**ADDRESS OF PROPERTY:** 2309 Dilworth Road West, *Dilworth Local Historic District*

**SUMMARY OF REQUEST:** Second Story Addition

# Charlotte Historic District Commission - Case 2013-169

# 2309 Dilworth Road West

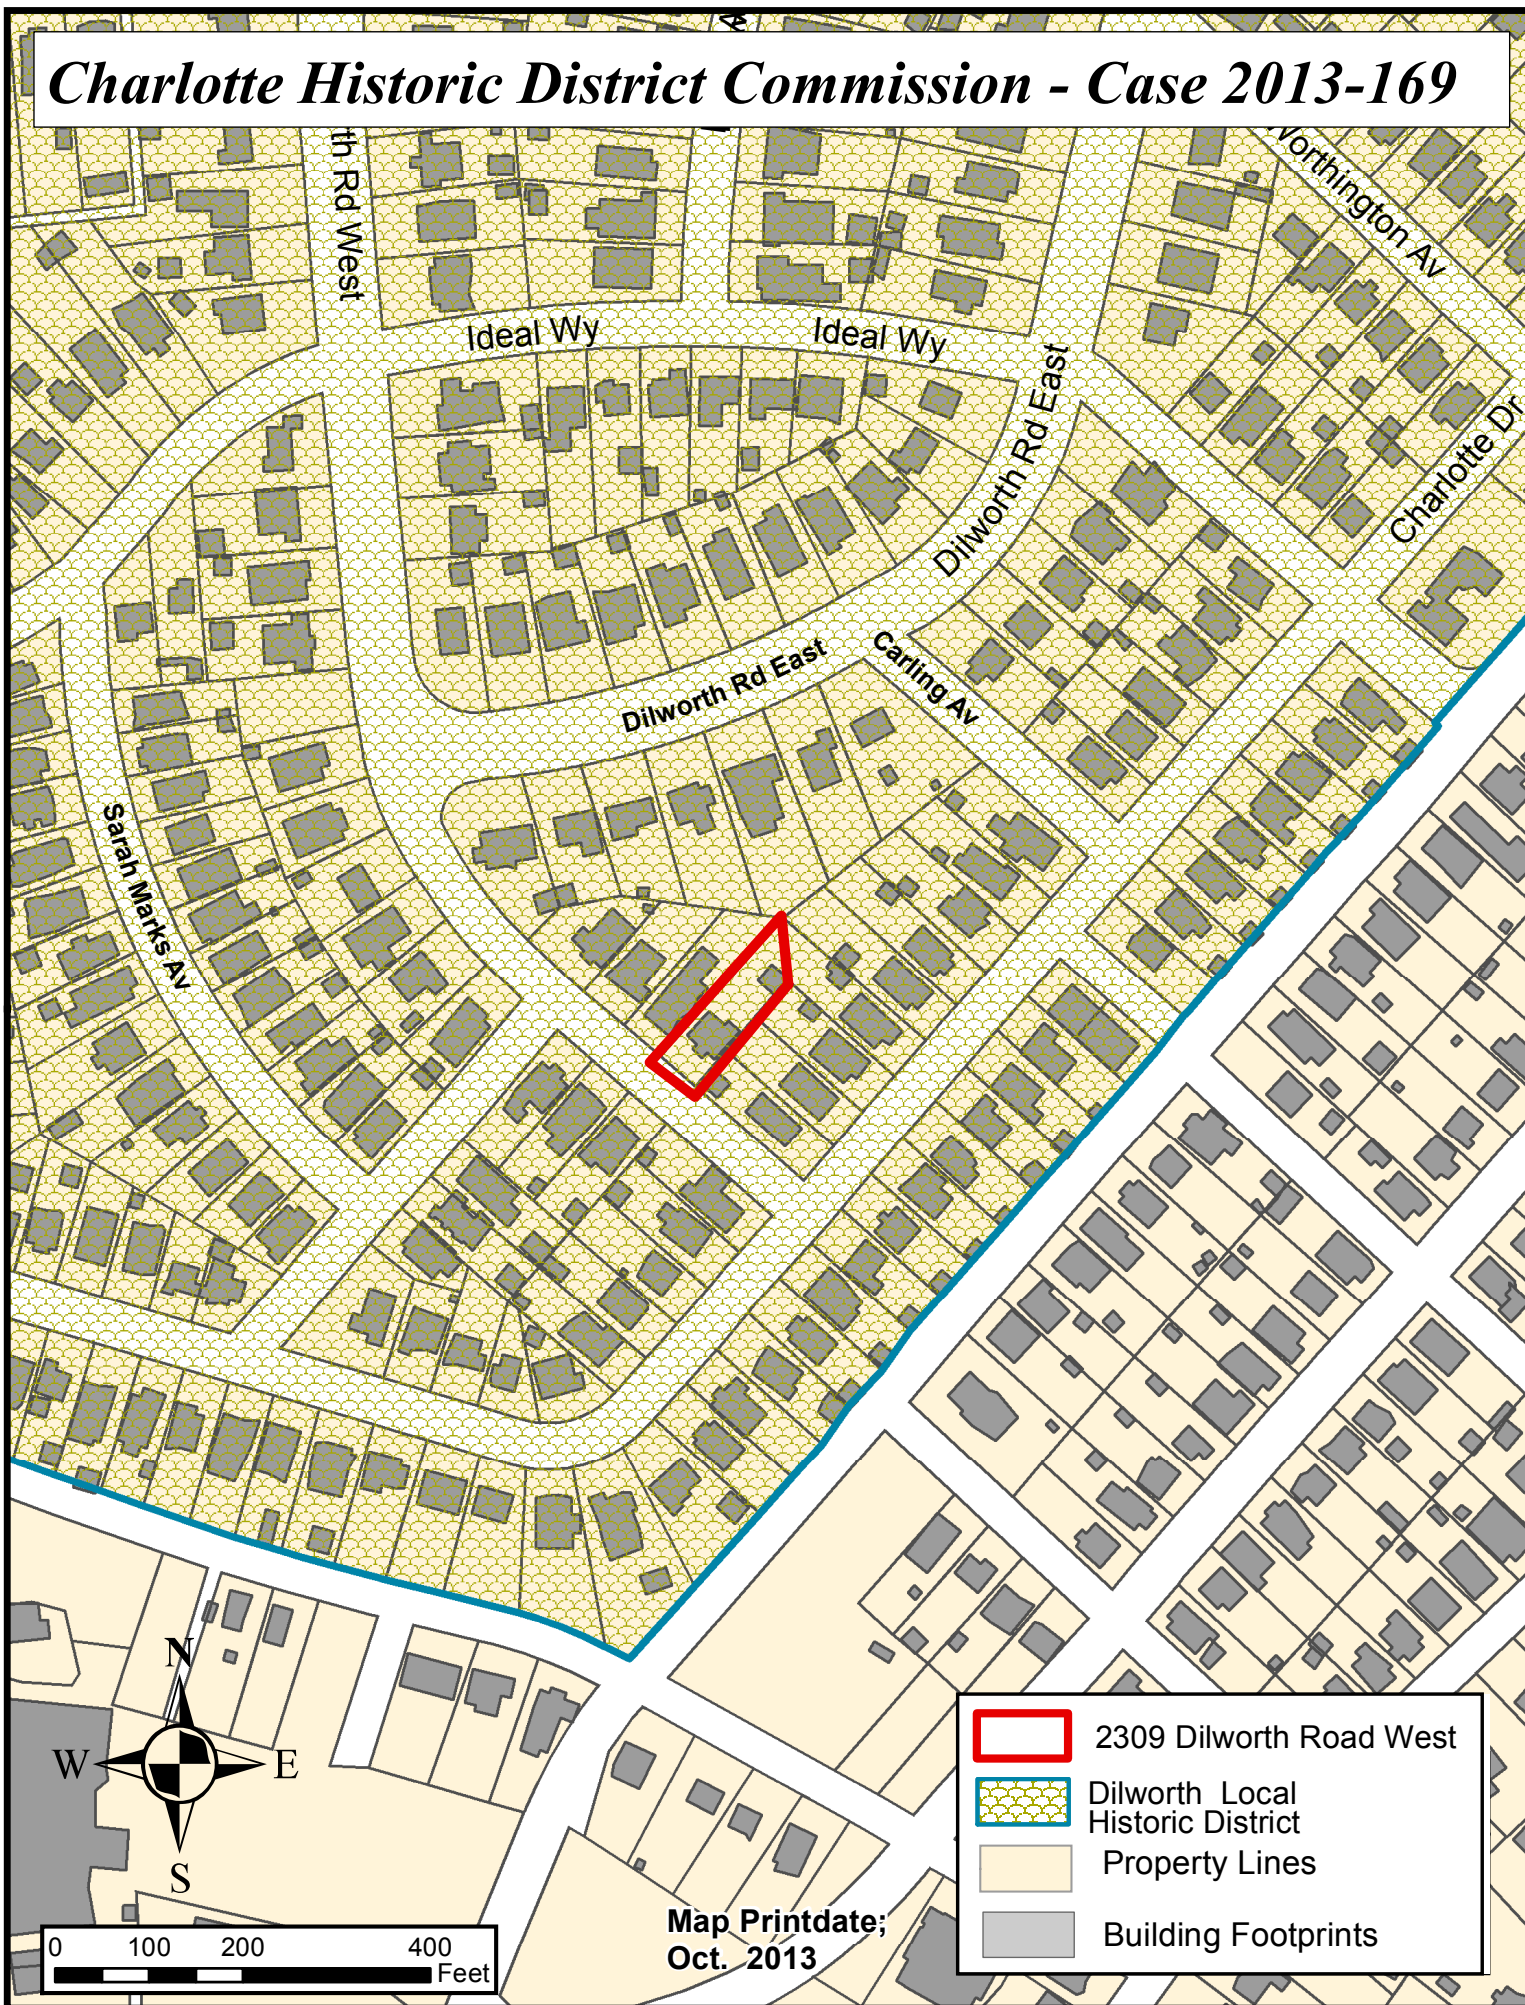
Scale – The full second story from front to rear increases the overall height of the home to those adjacent to it.

Massing – The massing of the home is improved with the addition of front and rear porches, side gables and stepping down part of the rear.

Fenestration – The arrangement of windows assists in establishing the rhythm of the façade and overall massing. Windows on the side elevations in some instances may not be proportionate or may be out of rhythm.

Context – The overall size and scale of the home is inconsistent with the existing character of the street. However, two story homes exist in the District adjacent to one or 1.5 story homes.
